CAPITOL ZONING DISTRICT COMMISSION
STAFF REPORT
9/28/2016
TDM / BIM

Location: 1512 South Spring Street
Applicant: Elizabeth Barnett and Mizan Rahman
Permit Type: Certificate of Appropriateness

Project Description: The applicant seeks approval to construct an addition to the house at 1512 Spring Street and make changes to the existing house. The existing structure's siding, roof, windows, and door will be replaced with wood lap siding, asphalt shingles, metal-clad wood windows, and a metal-clad glass panel door, respectively. The proposal includes relocating the front door to the south-facing wall on the porch and enclosing the existing opening. The addition will be sided with vinyl or metal, will use the same windows as the replacements on the existing house, and will incorporate similar roof lines. The addition will also include two-car garage accessed from the alley.

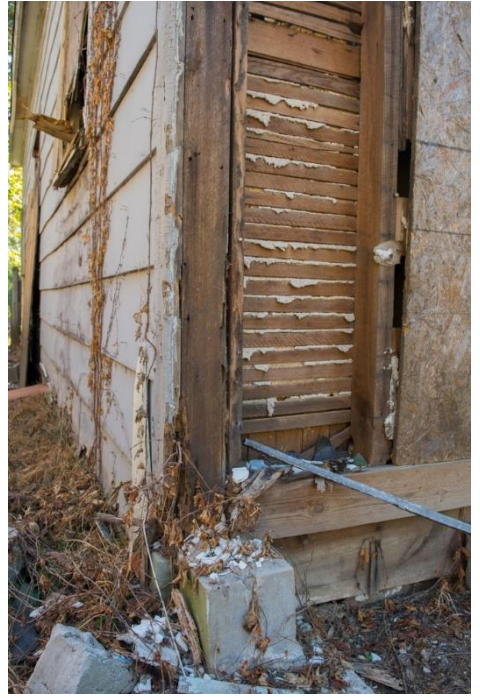
Staff finds that the proposal is not consistent with these standards. While the original door itself may no longer be present, the existing opening, trim, and transom appear largely unaltered. Enclosing the historic primary entrance and relocating it to a side wall would not be appropriate.

Front porch showing deteriorated, non-original materials and the historic primary entrance. The proposed new primary entrance would be located on the blank wall to the right of the existing front door.

- 1) That the location and arrangement of the primary entrance be preserved;
- 2) That all applicable State and City codes be followed at all times; and
- 3) That the property be maintained in a neat and safe condition at all times.

Boundary Survey of
1512 Spring Street,
Little Rock, Pulaski County, Arkansas
For: Mizan Rahman

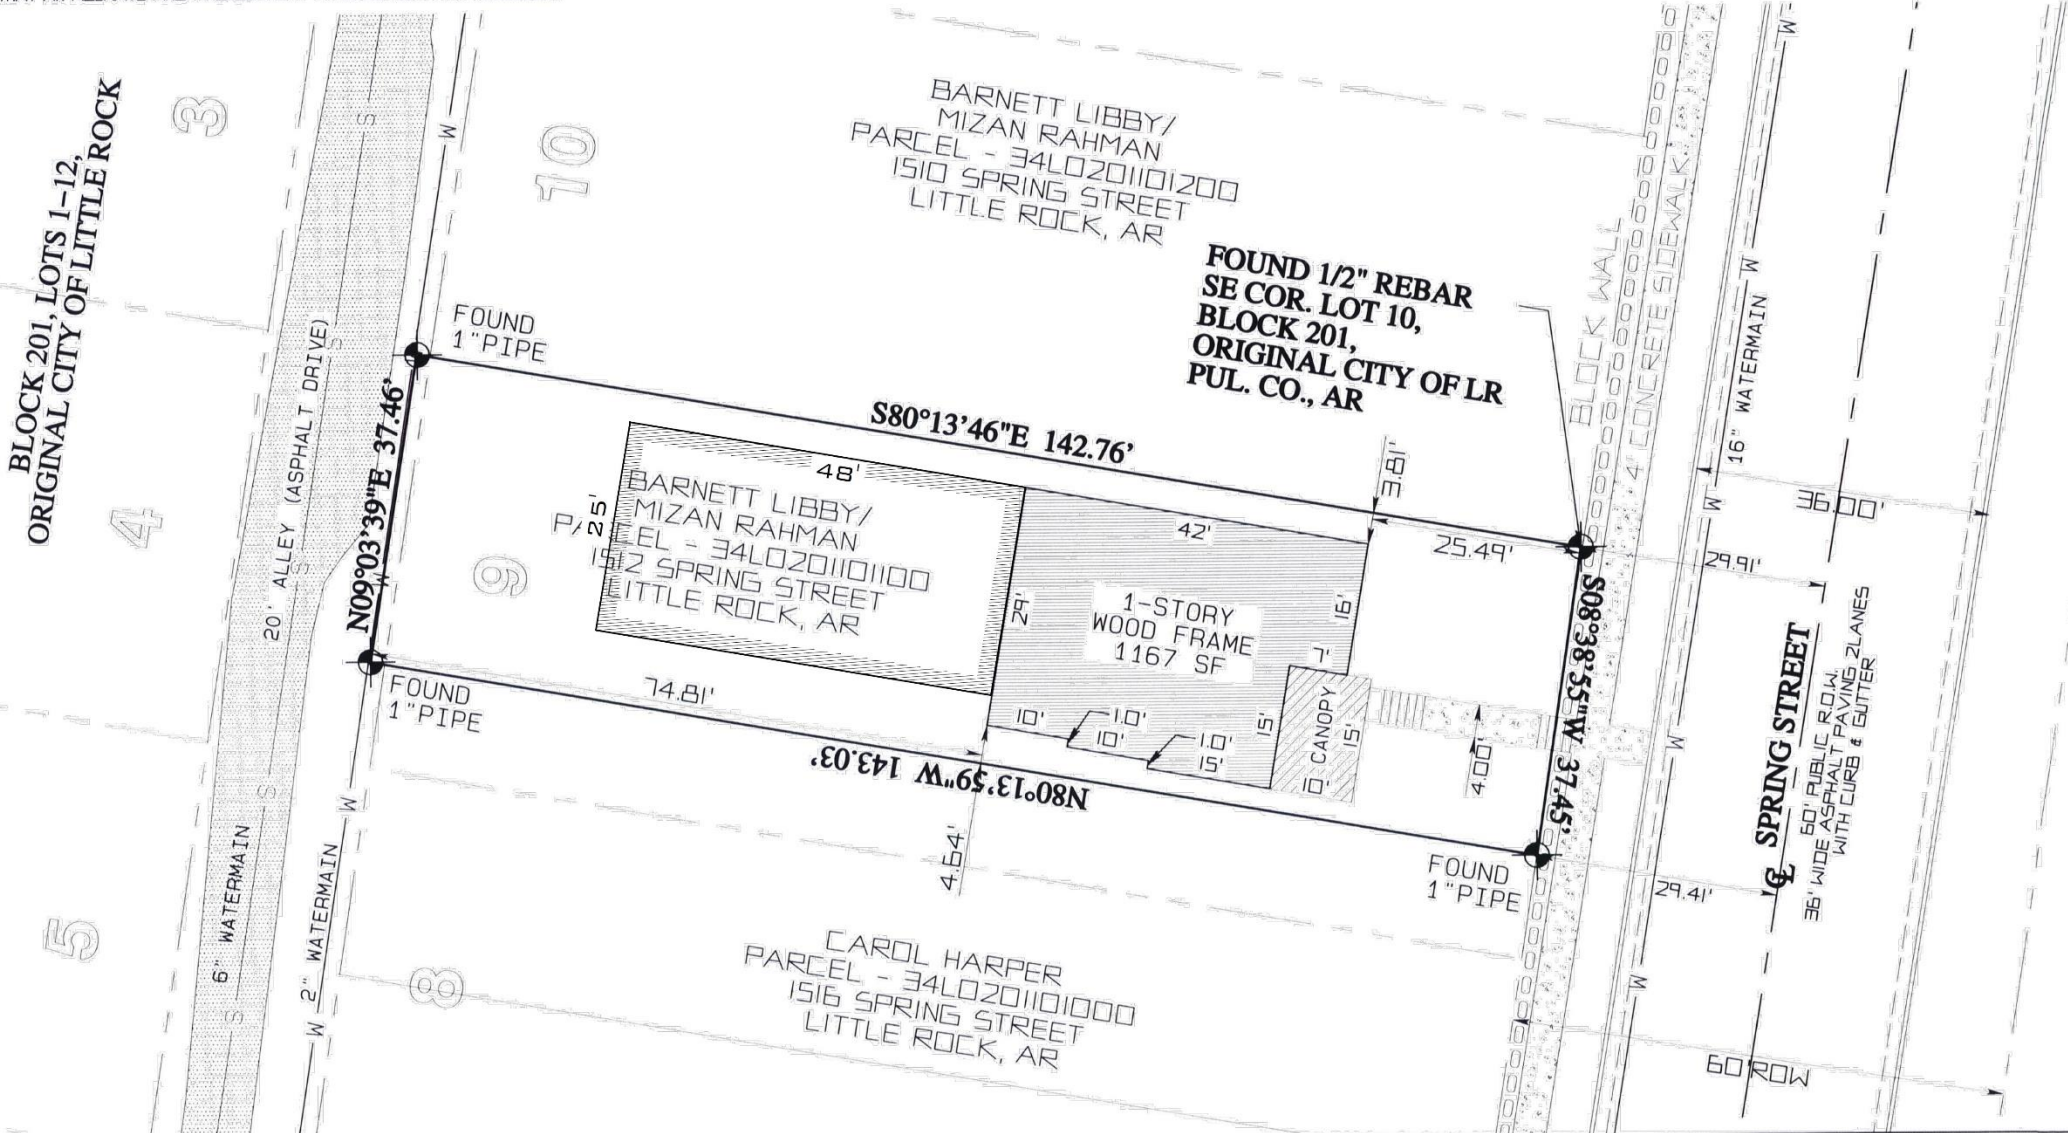
The proposal is consistent with the back yard setback requirement. However, the existing structure sits 3.81' from the north property line, closer than the 5' minimum allowed. The proposed addition would increase the property's nonconformity with the side yard setback rule by extending the north wall along the same line. However, see the provision for an exception below.

The lot at 1512 Spring Street is 37.5' wide, significantly less than the typical 50' found throughout the neighborhood. A 25% reduction in the required 5' setback would result in a 3.75' allowed setback. The proposed addition is located 3.8' from the property line. Staff feels this exception should be granted because of the lot's narrow width.
